# POSITION PAPER

## COMMENTS ON THE REGULATIONS ABOUT ECODESIGN AND ENERGY LABELLING REQUIREMENTS FOR SPACE AND WATER HEATERS

Brussels, June 2023

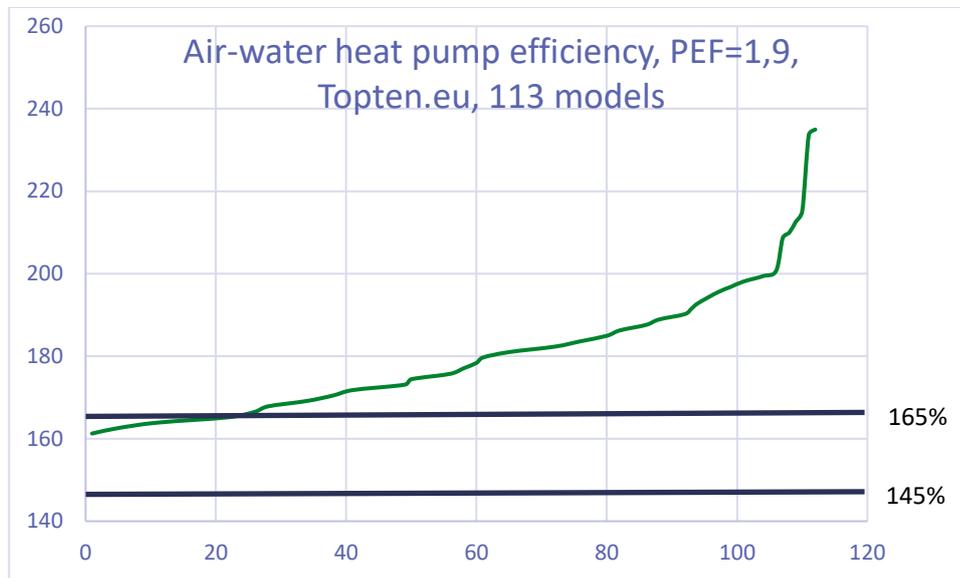
The proposed efficiency **for MT heat pumps** is currently 145% with the current PEF. According to [Topten.eu](https://www.topten.eu) and the [Danish Varmepumpelisten](https://www.danishvarmepumpelisten.dk) databases, the lowest efficiency of MT heat pump is already 161%.

Because Ecodesign should reflect the technological development of heating appliances in the market, we consider 145% not ambitious enough, and we propose to raise it **up to 165% for the 1<sup>st</sup> tier and 200% for 2<sup>nd</sup> tier** for MT regime.

Below, the graph shows the efficiencies of 113 heat pump models included in Topten.eu in MT regime and the proposed efficiency limits for the 1<sup>st</sup> tier, with recalculation from PEF=2,5 to PEF=1,9.

Similarly, for **LT heat pumps**, our suggestion is to raise the current 170% as in the proposals for both tiers, **up to 220% for the 1<sup>st</sup> tier and 250% for the 2<sup>nd</sup> tier.**
